RE: 130 Vasona Oaks Drive

I reviewed the drawings and evaluated the neighborhood context. My comments and recommendations on the design are as follows:

**REAR ELEVATIONS**

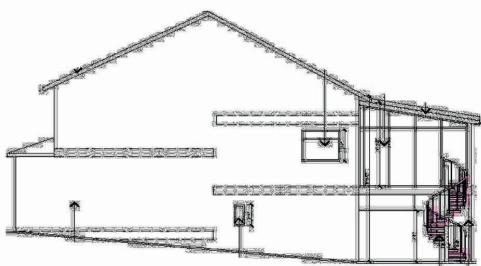
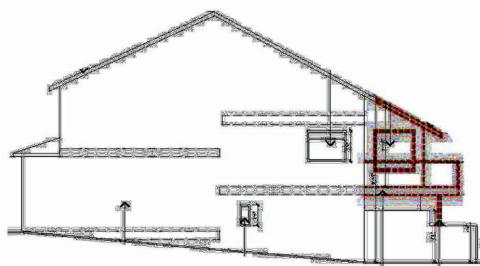
2. The treatment of the substantial second floor addition as a sunroom with fully glazed walls and ceiling would be quite out of character with the current home's architectural style and immediate neighborhood and it would not be consistent with Residential Design Guidelines 3.2.2 and 3.8.2.

### Second Floor

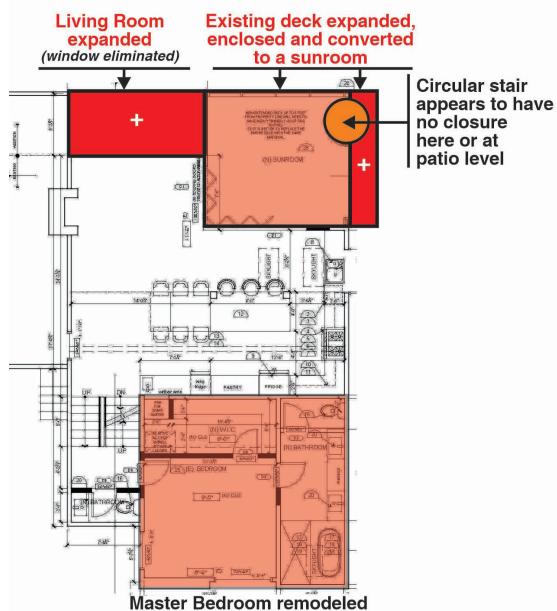
- Expand the Living Room at the rear.
- Replace the existing rear deck, expand its size on the side facade and create a large Sunroom.
- Add a circular staircase to connect the second floor Sunroom to the patio below.
- Remodel the existing Master Suite.

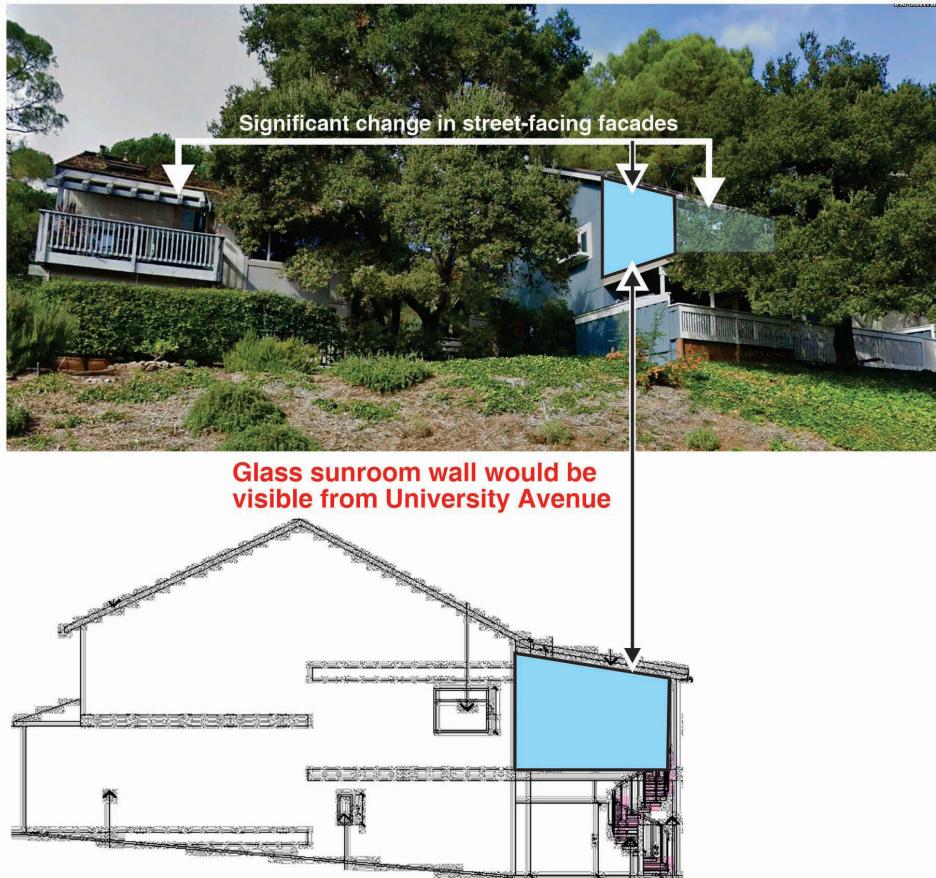
3. The proposed circular stair does not appear to be protected from the outside environment at either level.

While the addition would be partially screened from University Avenue views by virtue of some existing mature tree landscaping, there is no guarantee that the landscaping will always remain. In any event, the proposed glass faced sunroom would still be clearly seen from University Avenue and would be in stark contrast to the balcony front facade on the adjacent home - see photo illustration below,

### **3.5.3 Relate roof overhangs to the architectural style and to the surrounding neighborhood**

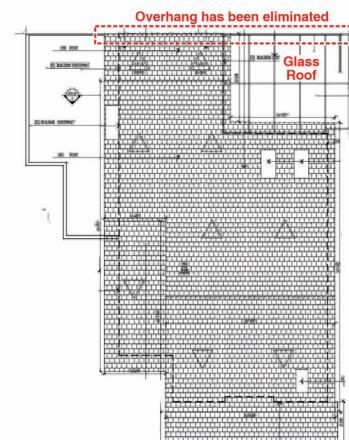
4. The Living Room window facing University Avenue has been removed with the proposed Living Room addition.
5. The new facades facing University Avenue would not include any roof overhangs which are a common feature on this house and others nearby. This would not be consistent with Residential Design Guidelines 3.5.3.

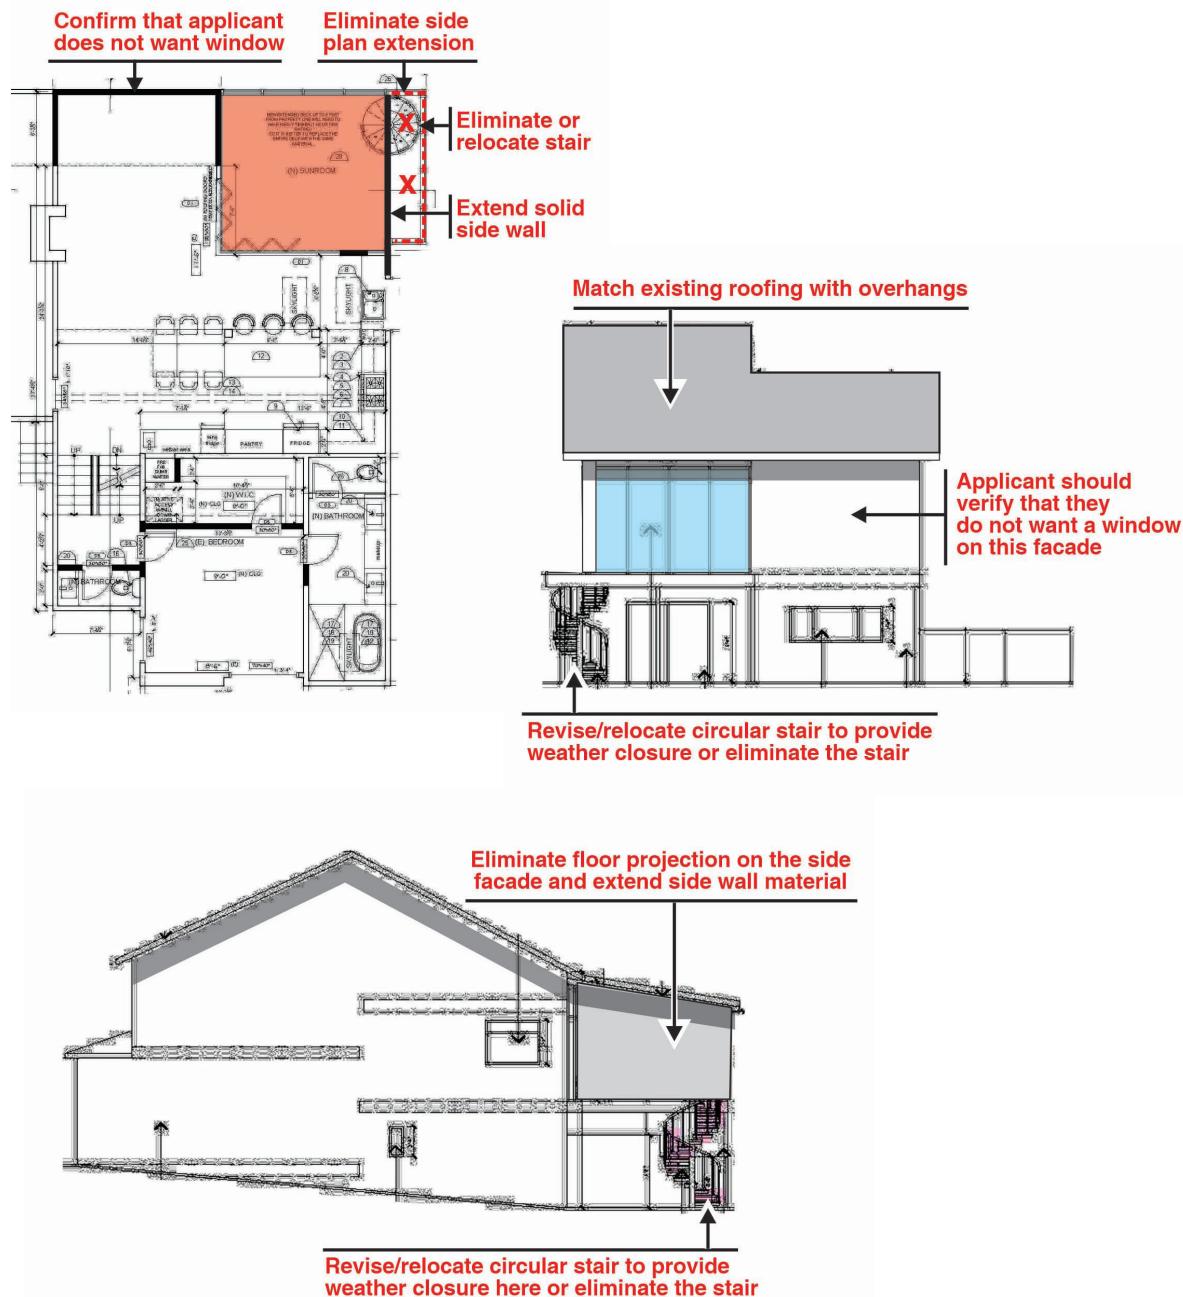
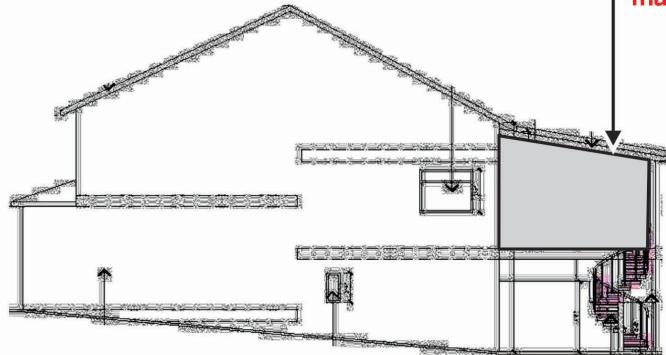
The proposed Sunroom addition, with its extensive use of wall and roof glazing, would not be compatible with the immediate neighborhood and would not be consistent with the town's Residential Design Guidelines. My recommendations below are limited to suggestions for improving the design in the context of allowing the additions.

1. Eliminate the added room floor plan extension into the side yard.
2. Extend the solid side wall along the added room.
3. Eliminate the stair case or relocate and design it to be functional.
4. Eliminate the glazed roof on the added room and replace with roofing to match the original - provide overhangs consistent with the existing roof.

Extend solid side wall  
materials and color
